**REVISS Services
Quality and Regulatory Group**

Technical Memorandum

**R7021 Transport Container
Design Justification**

1. PURPOSE AND SCOPE

Figure 1: R7021 Assembly

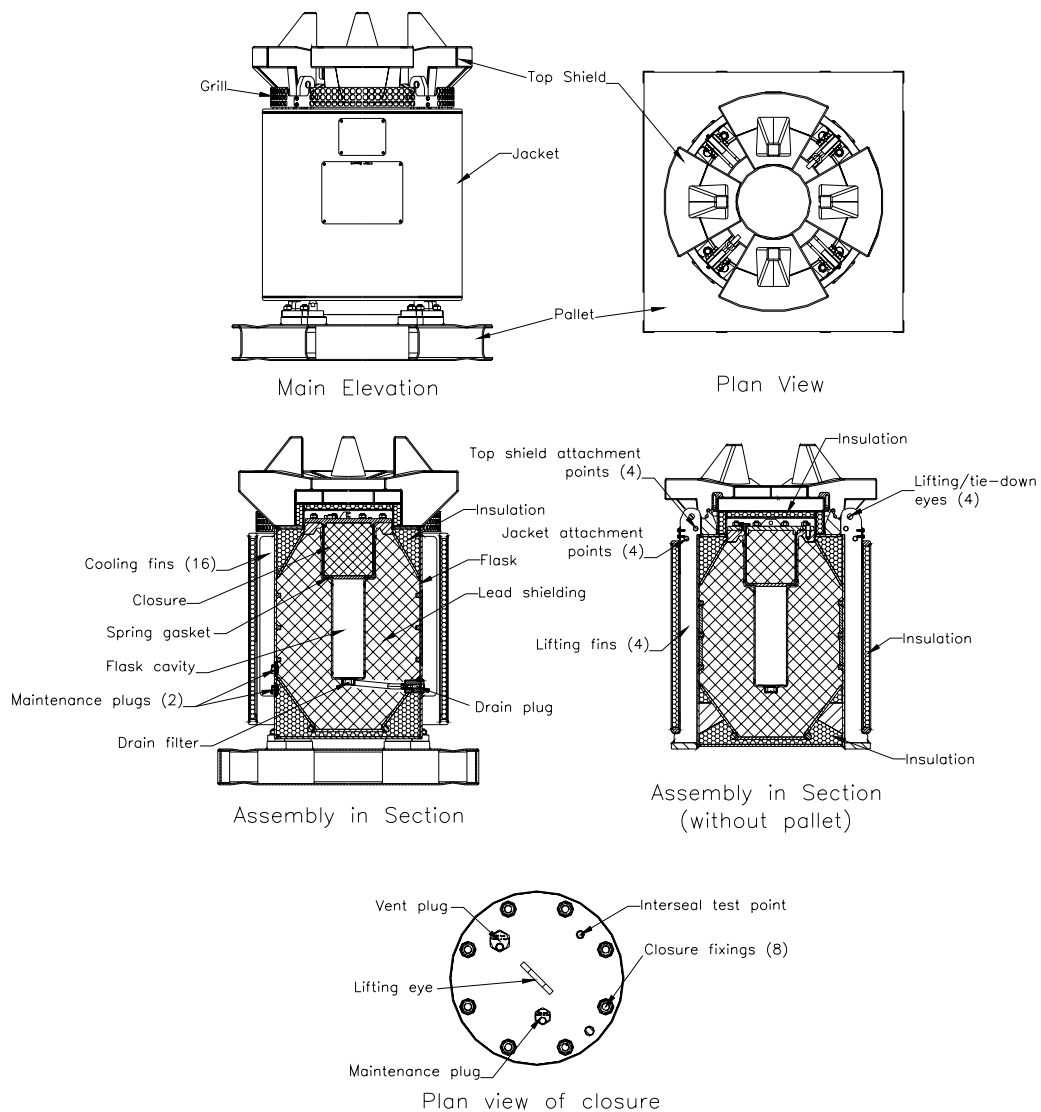
The design consists of a shielded, stainless steel flask mounted on a pallet and protected from heat and impact by a jacket and top shield (Figure 1). The maximum gross weight is 4,600 kg.
